Refer to: HSA-10/WZ-112

Thank you for your letter of February 28, 2002, requesting Federal Highway Administration (FHWA) acceptance of your company's Type II barricades as crashworthy traffic control devices for use in work zones on the National Highway System (NHS). Accompanying your letter was a comparison of your design to the design crash tested by EmpcoLite, and to the generic crash tested design that was distributed in FHWA Acceptance Letters WZ-49 and WZ-54 respectively. You requested that we find these devices acceptable for use on the NHS under the provisions of National Cooperative Highway Research Program (NCHRP) Report 350 "Recommended Procedures for the Safety Performance Evaluation of Highway Features." You also requested acceptance of a PVC legged barricade which is not acceptable unless crash tested.

CAMSCO SERVICE INC. PLASTIC RAIL & STEEL LEG WITH WARNING LIGHT TYPE II BARRICADE

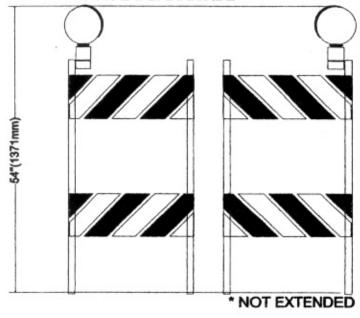
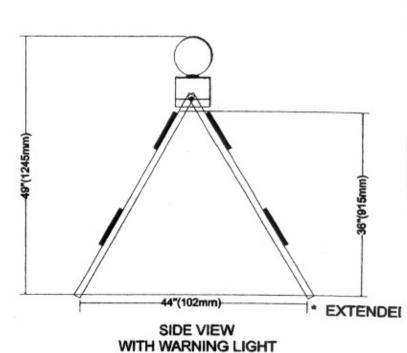
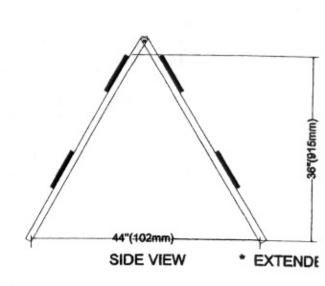
Your barricade with warning light is within the range of the tested barricades. The steel legs are marginally lighter than the tested designs (32 x 29 mm vs.the 32x32 mm as tested), and the HDPE horizontal panels have also been successfully tested on other Type II and Type III barricades. The overall mass of your barricade with light (12.25 kg) is less than the tested barricade with light (13.2 kg). The EmpcoLite 400 series warning light is too heavy to qualify as a "lightweight" warning light under our "generic" barricade memorandum WZ-54, but it is the identical light crash tested and accepted in our letter WZ-49. The warning light is to be affixed directly to the steel frame using 12.7 mm (½ inch) diameter hex screws and lock nuts. A vandal-resistant cupped washer is also to be used to help keep the light attached to the barricade.

Because of the clear similarities between your Type II barricade with light, and the crash tested version discussed above, we find your Type II metal legged barricade with plastic panels, with or without warning light, shown in the enclosed drawings for reference are acceptable for use on the NHS under the range of conditions tested, when proposed by a State.
